REVISION	DATE	DESCRIPTION	BY
1	03/11/21	ISSUE FOR \$4.56	CH/PH
2	02/12/21	ISSUE FOR \$4.56	CH/PH

- REVISION NOTES**
- DRIVEWAY AMENDED TO SUIT RFS REQUIREMENTS FOR ACCESS TO NO.16 WYATT AV.
  - COOKTOPS ADDED TO LODGER ROOMS

**NORTHERN BEACHES ESSENTIAL SERVICES ACCOMMODATION**

14 WYATT AVE, BELROSE, NSW

DRAWING TITLE	SCALE	STATUS	NUMBER	REVISION	PROJECT
<b>SITE PLAN</b>	1:250 @A3	\$4.56	02	2	WAB

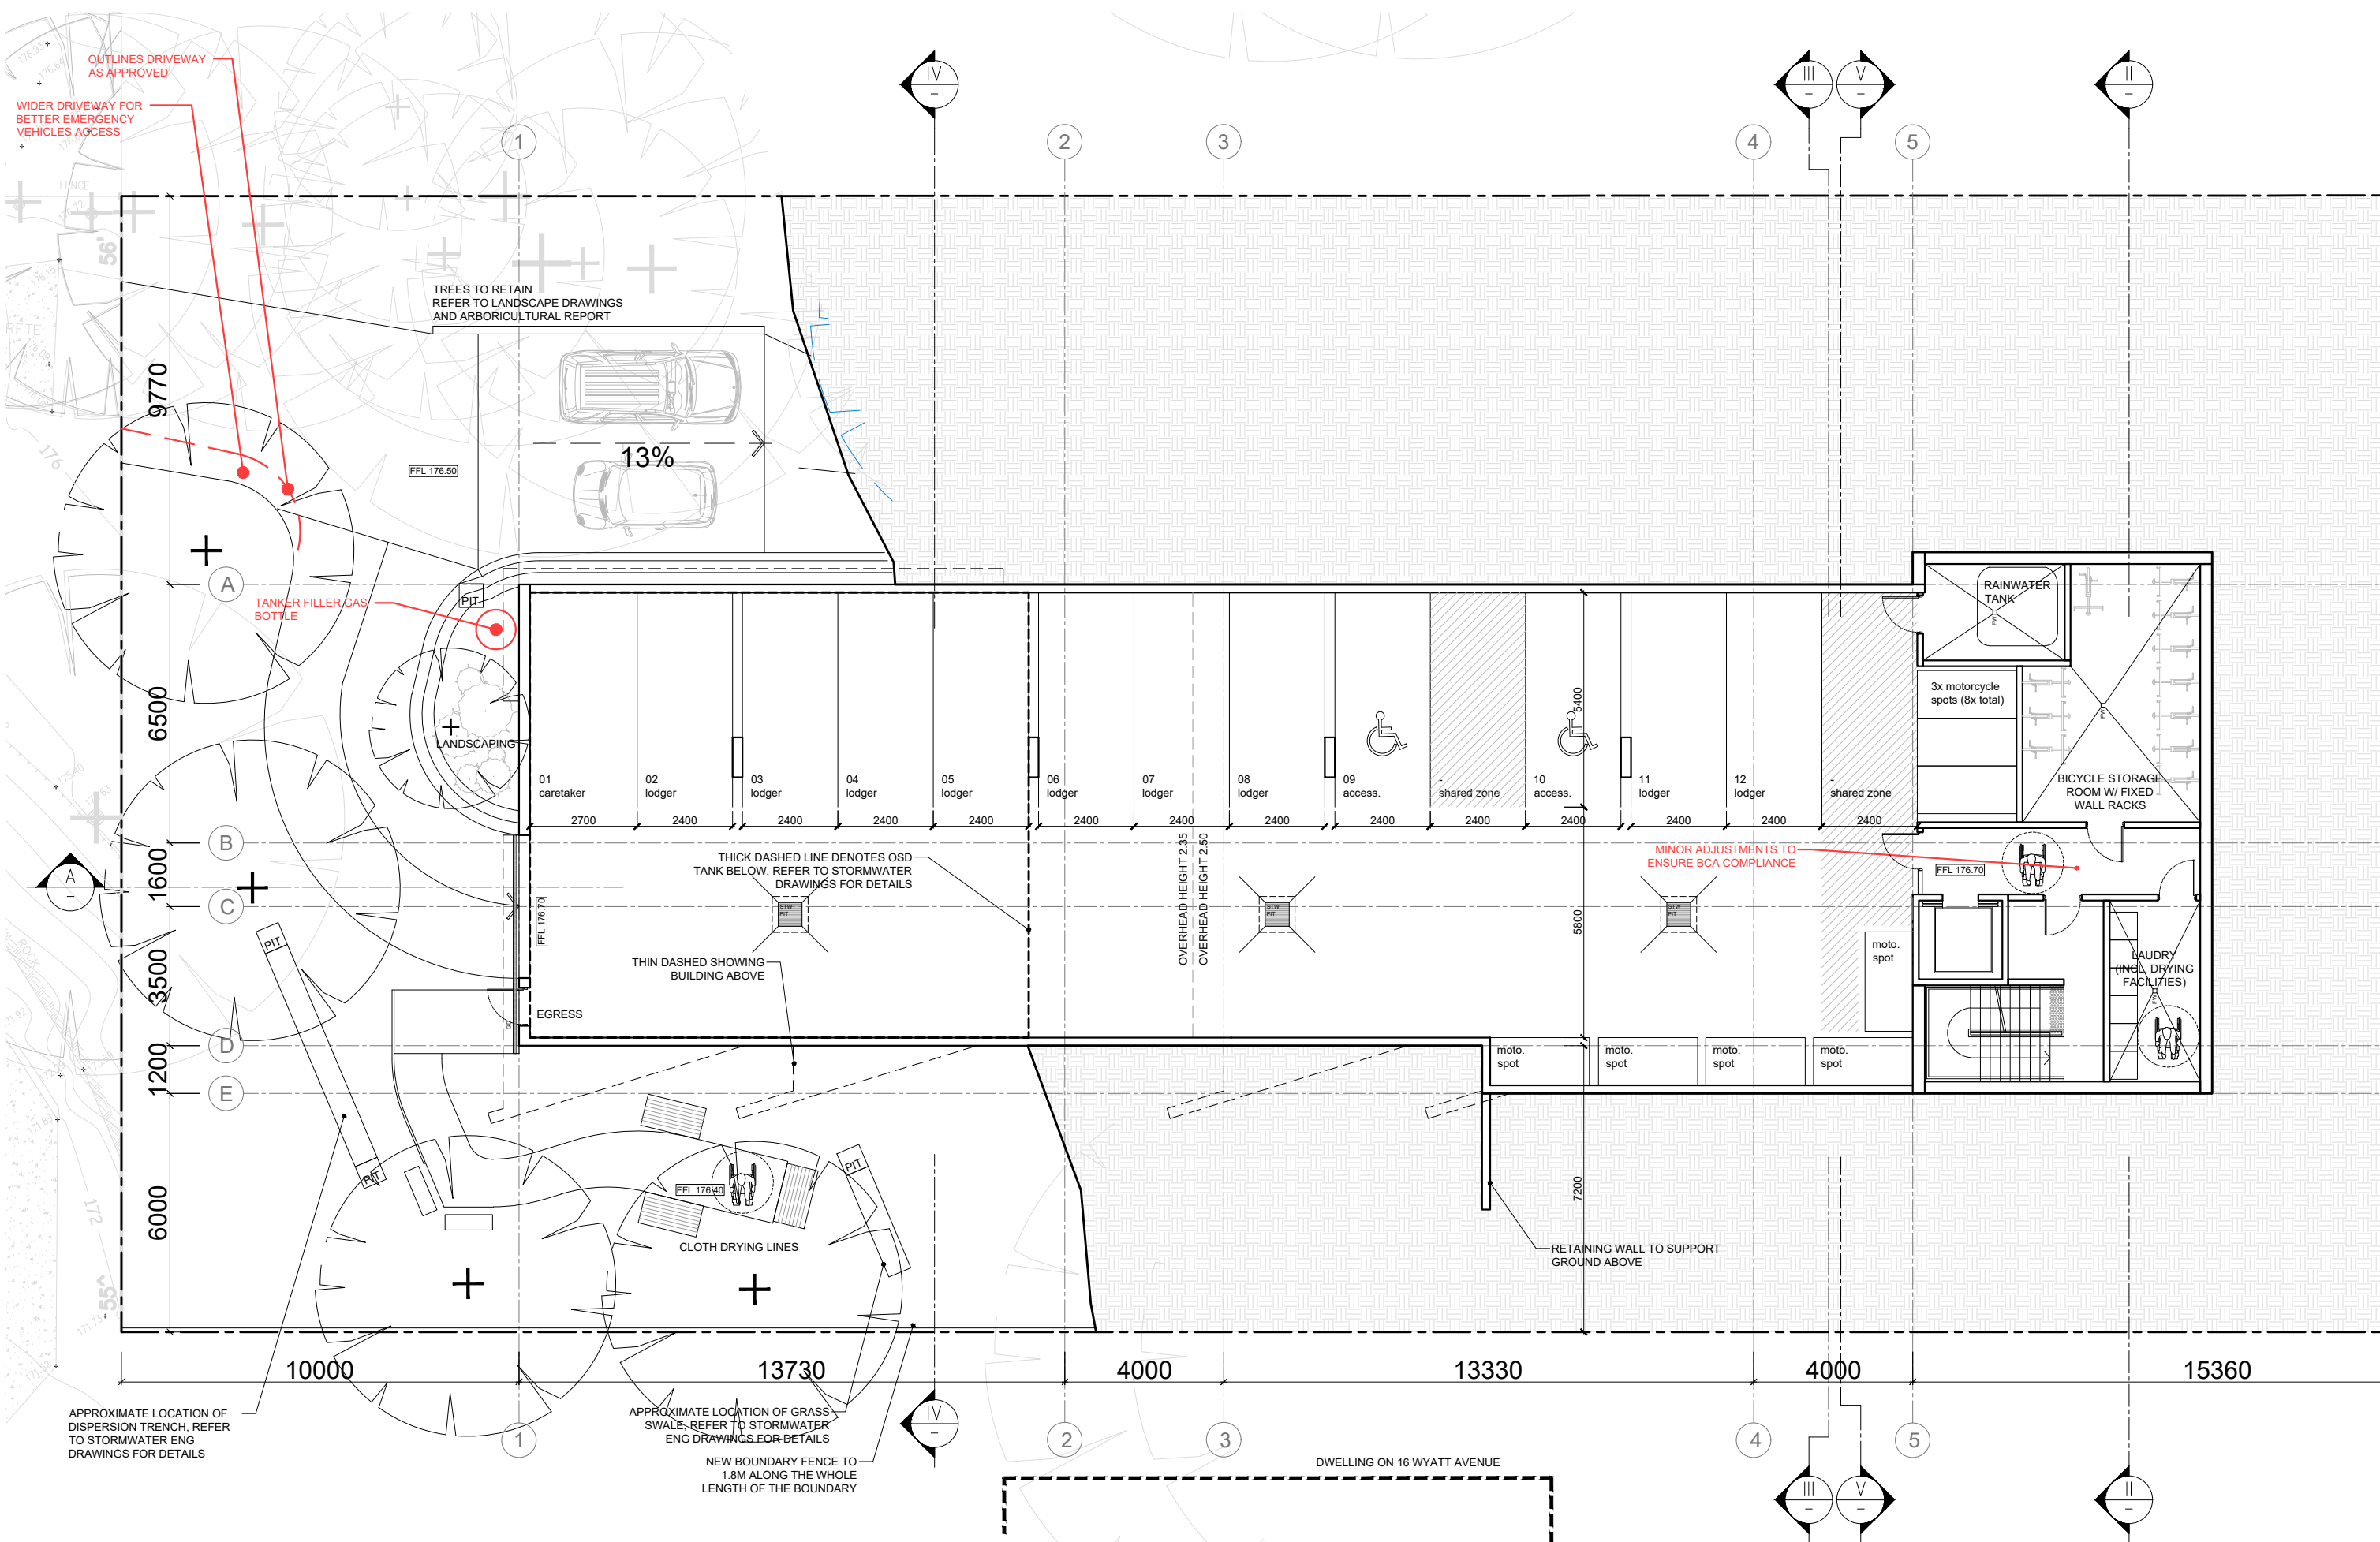
WIDER DRIVEWAY FOR BETTER EMERGENCY VEHICLE ACCESS

OUTLINES DRIVEWAY AS APPROVED

WIDER DRIVEWAY FOR BETTER EMERGENCY VEHICLES ACCESS

OUTLINES DRIVEWAY AS APPROVED

BIN STORAGE ROOM RELOCATED AS PER WASTE REFERRAL RESPONSE

DRAWING TITLE	PROJECT		
<b>SECOND BASEMENT PLAN</b>	<b>WAB</b>		
SCALE	STATUS	NUMBER	REVISION
1:150 @A3	\$4.56	03	2

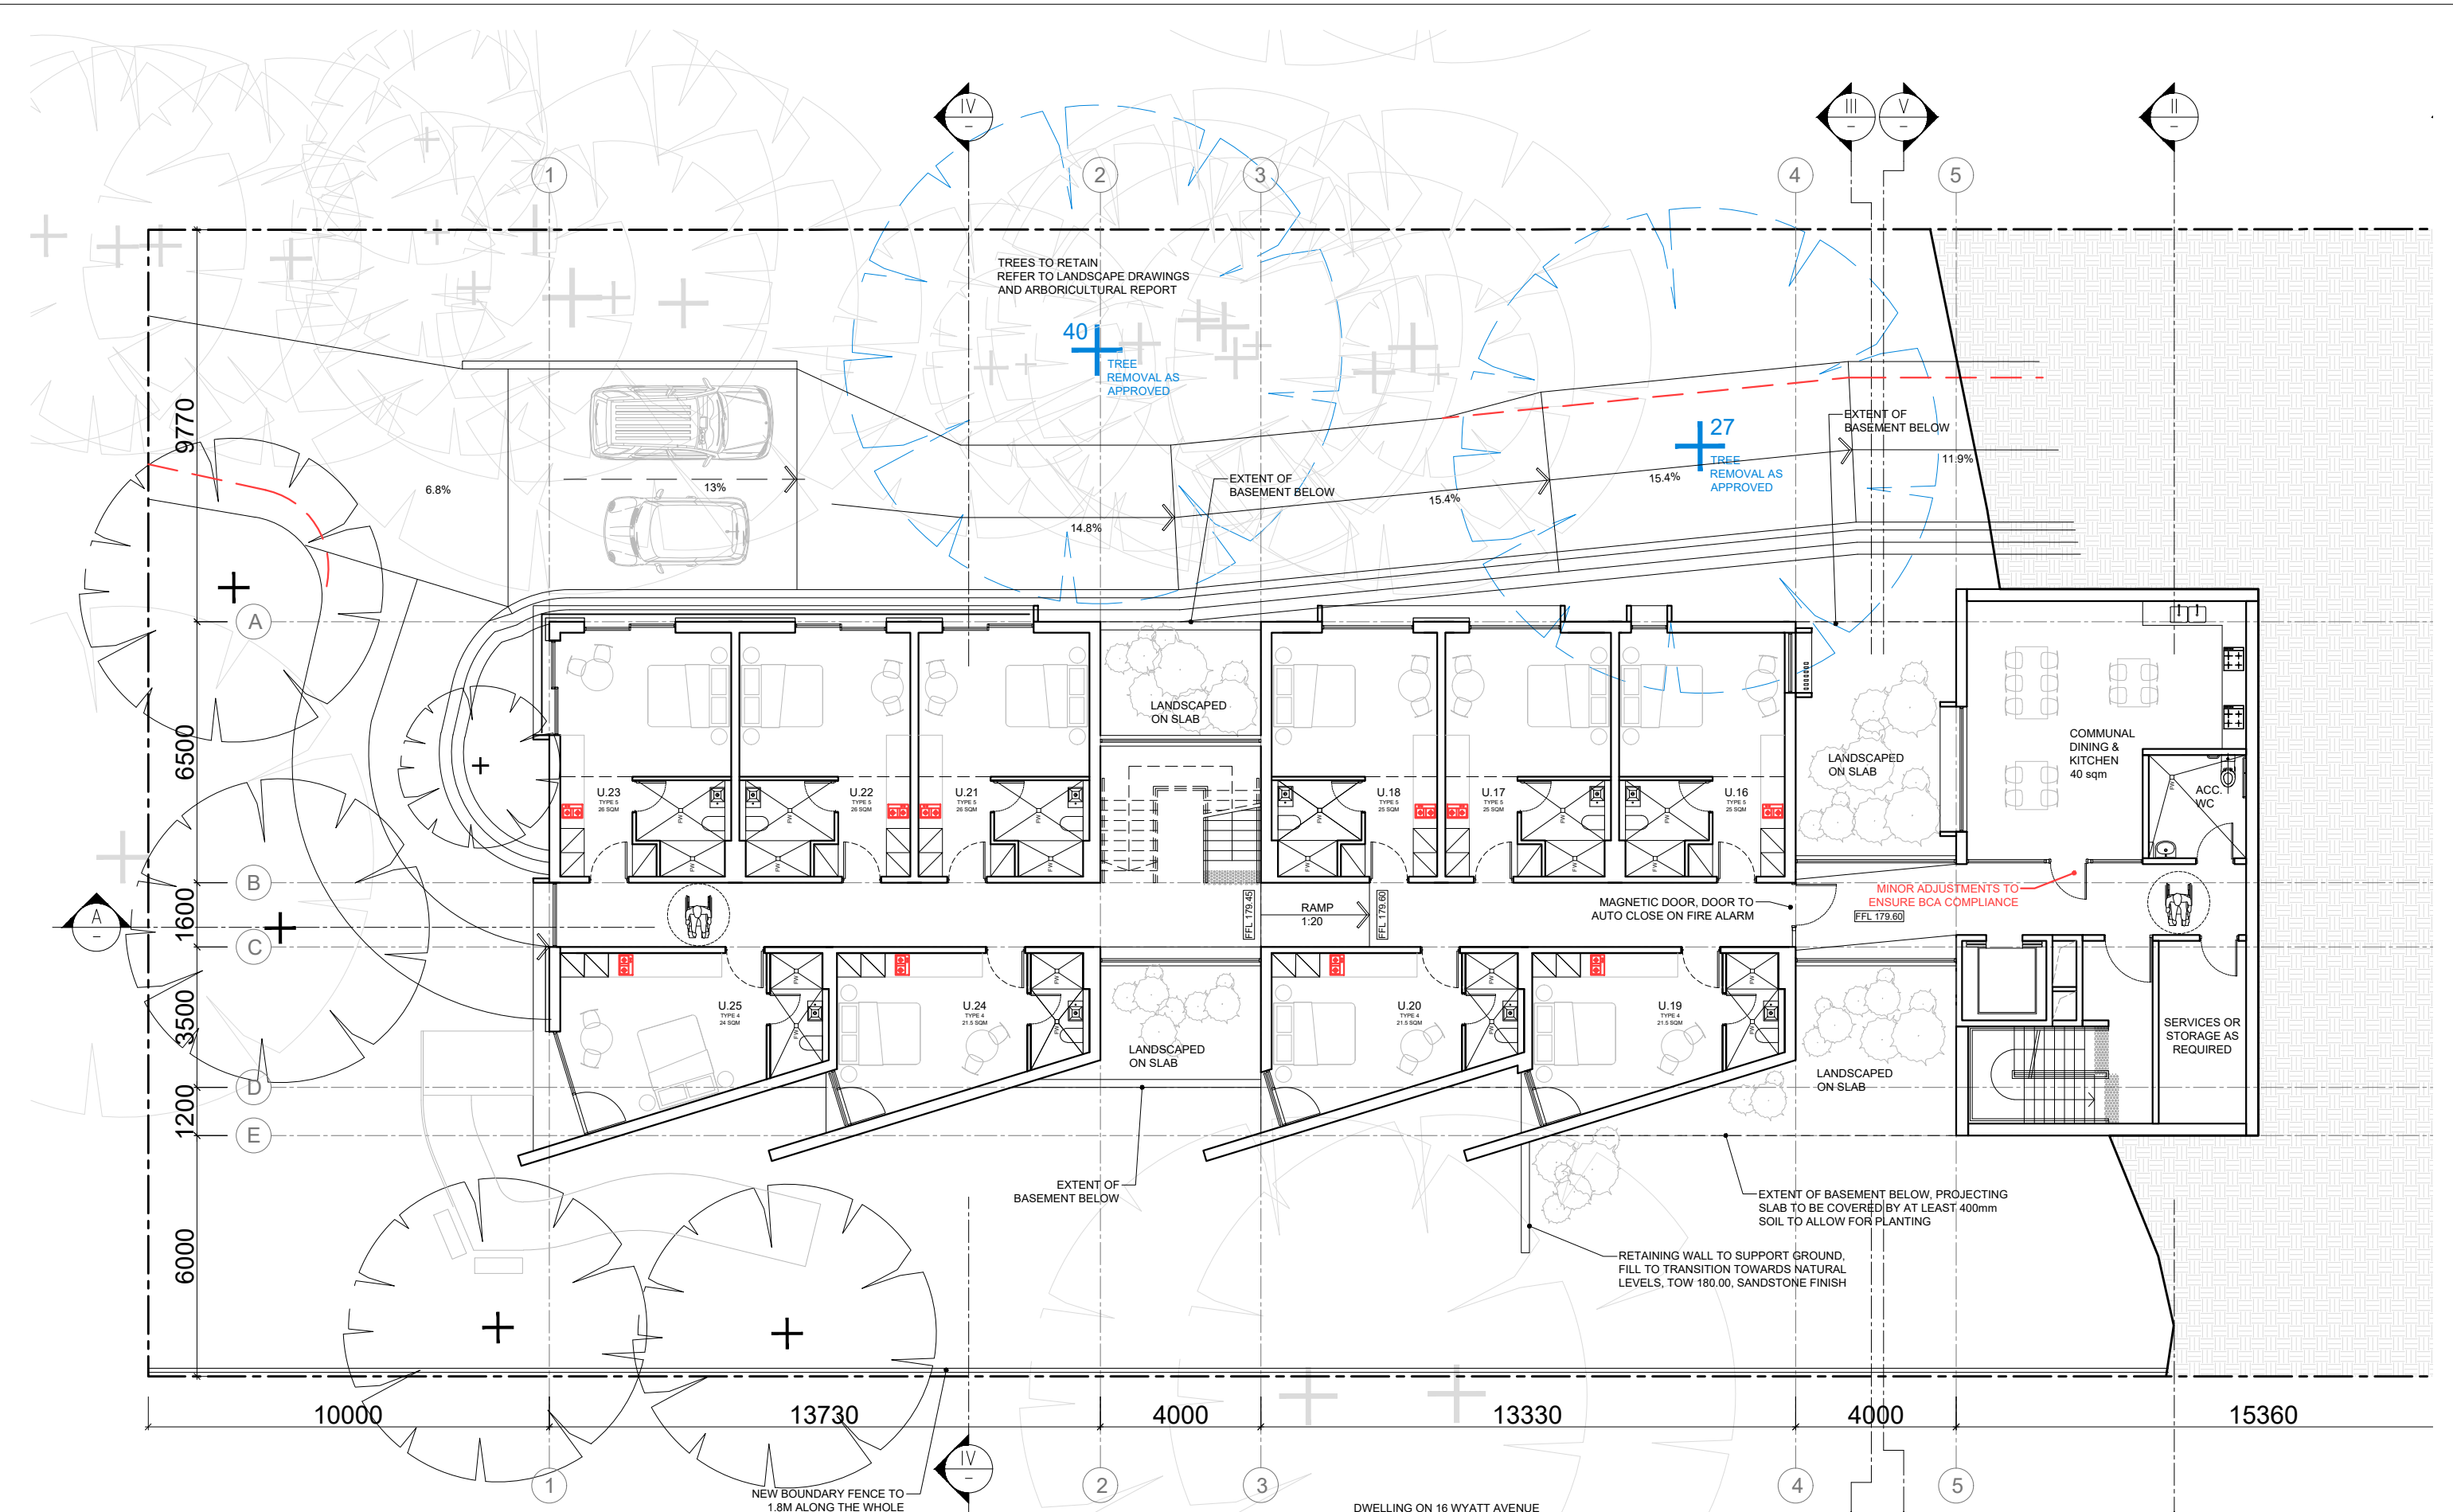
**AMENDMENTS TO APPROVAL:**  
**COOKTOPS ADDED TO LODGER ROOMS**

**DRAWING TITLE**  
 FIRST BASEMENT PLAN

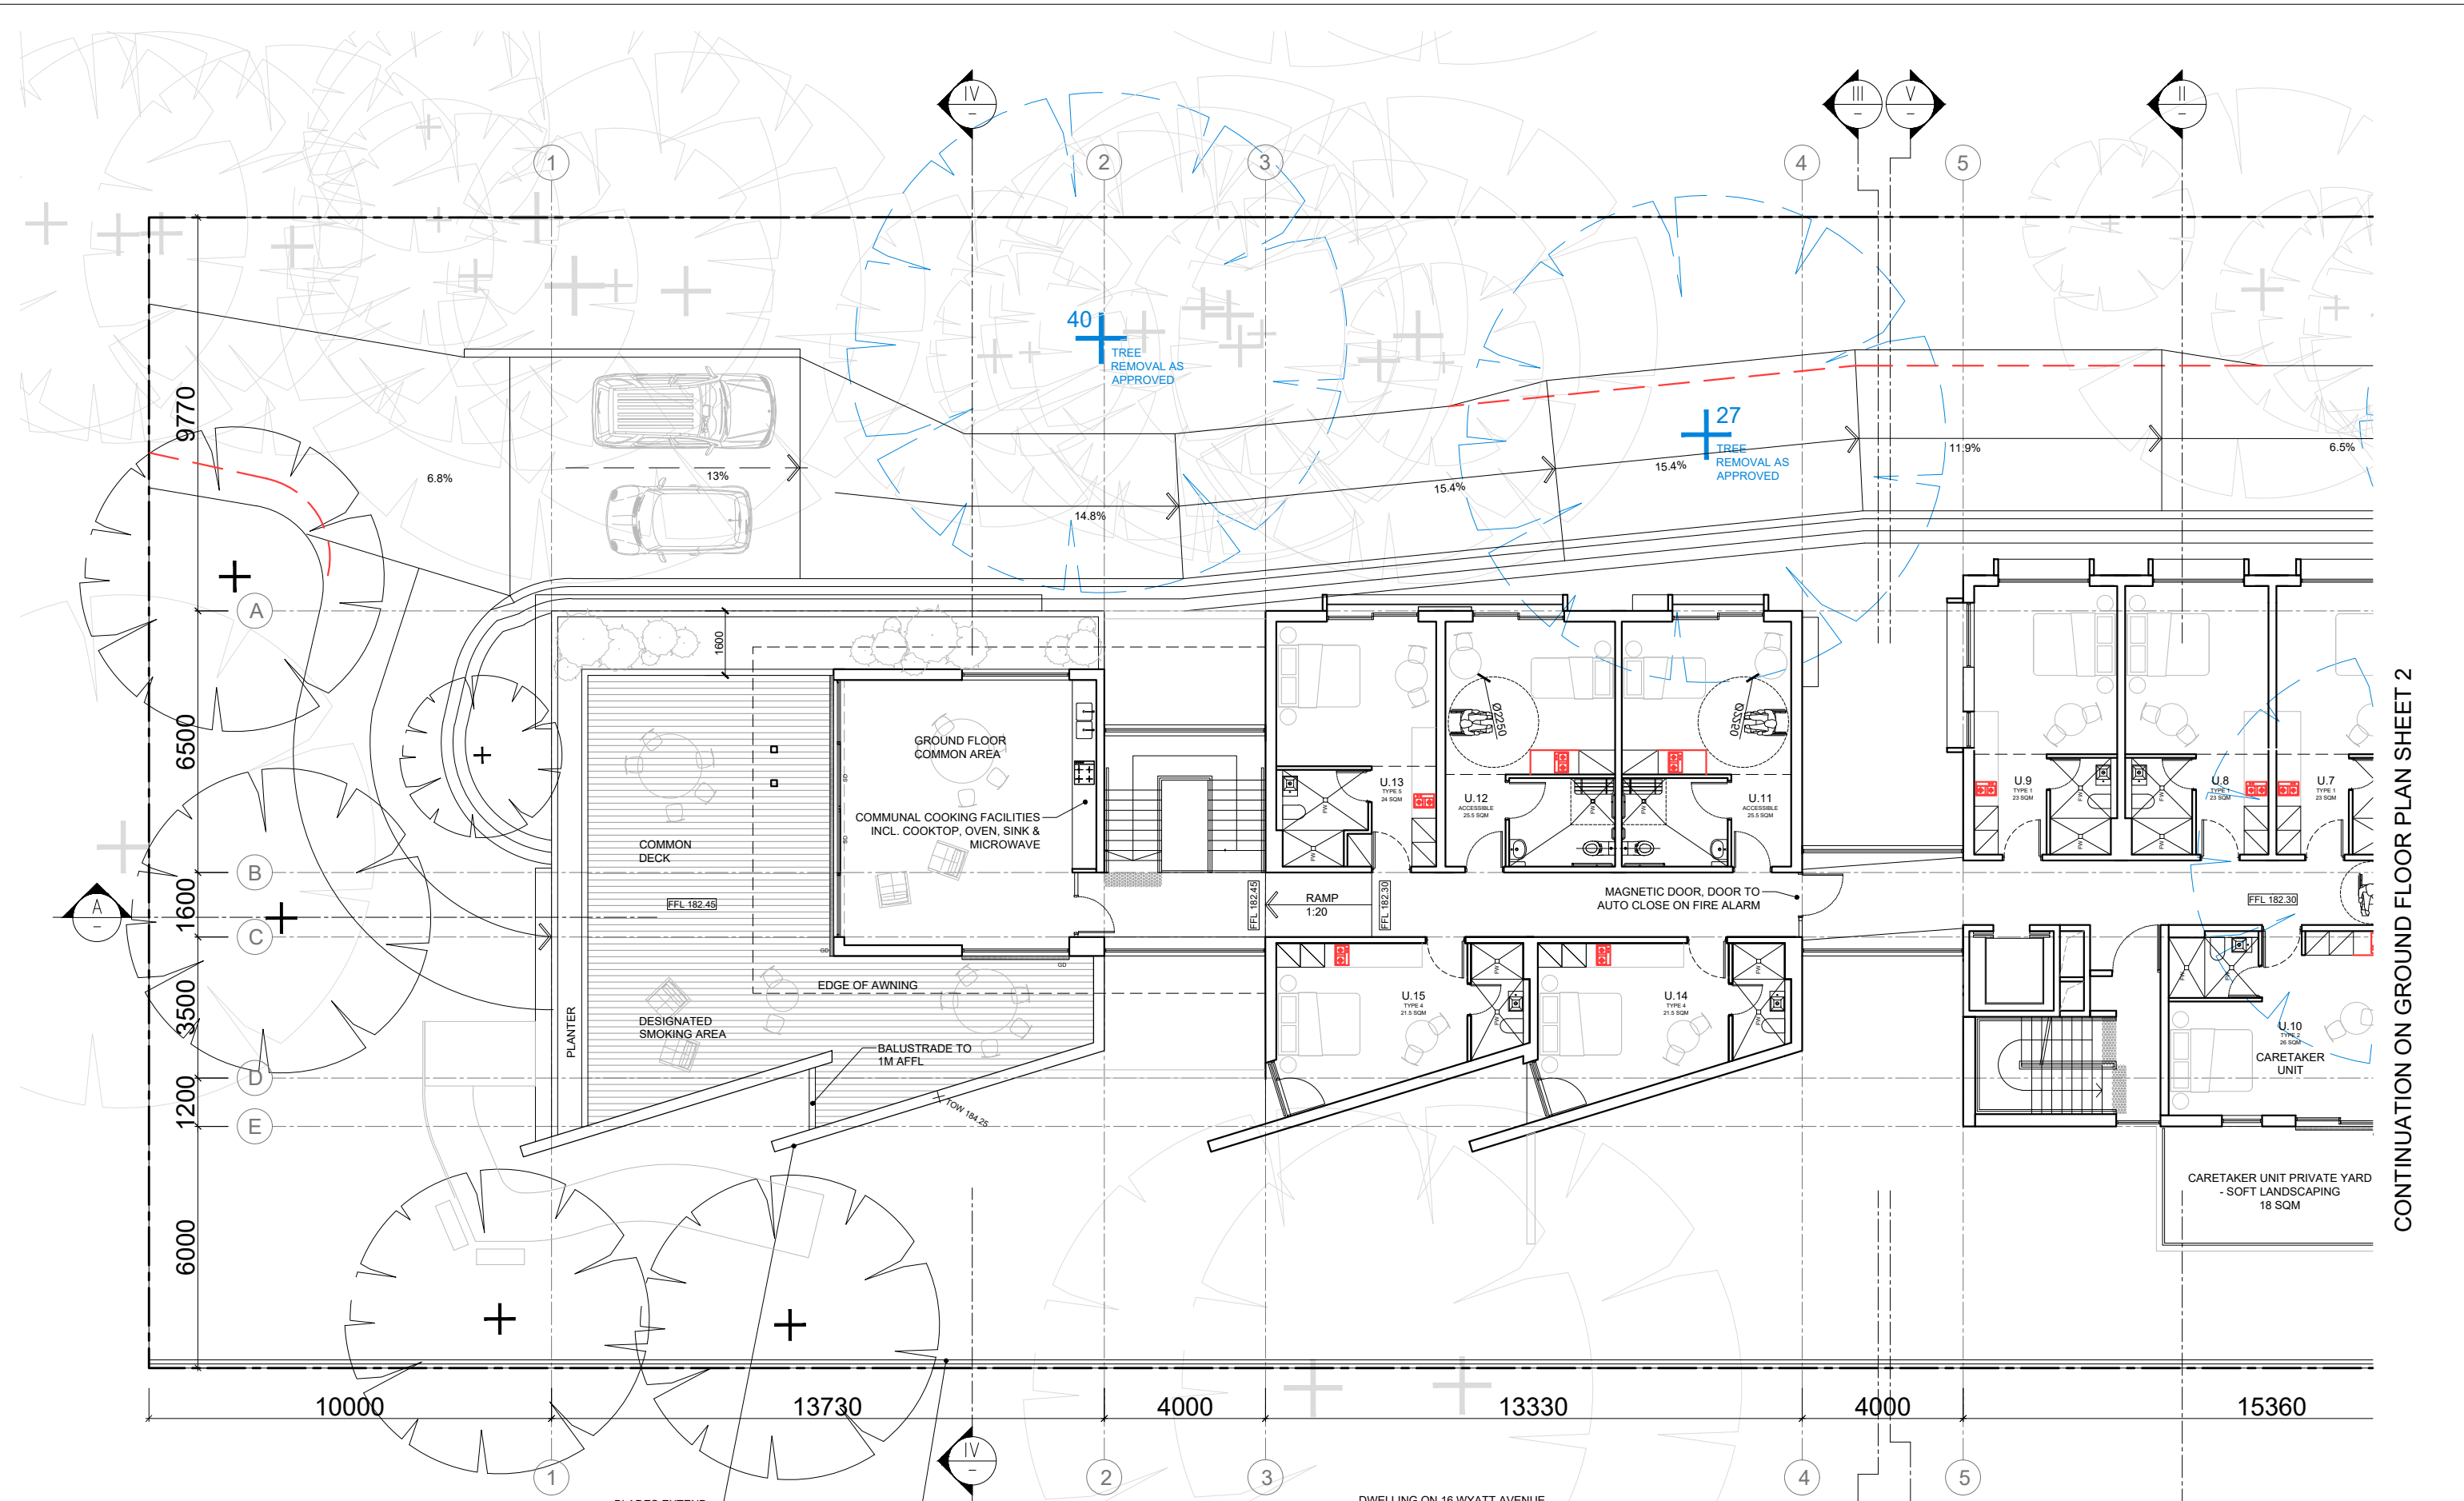
**AMENDMENTS TO APPROVAL:**  
**COOKTOPS ADDED TO LODGER ROOMS**
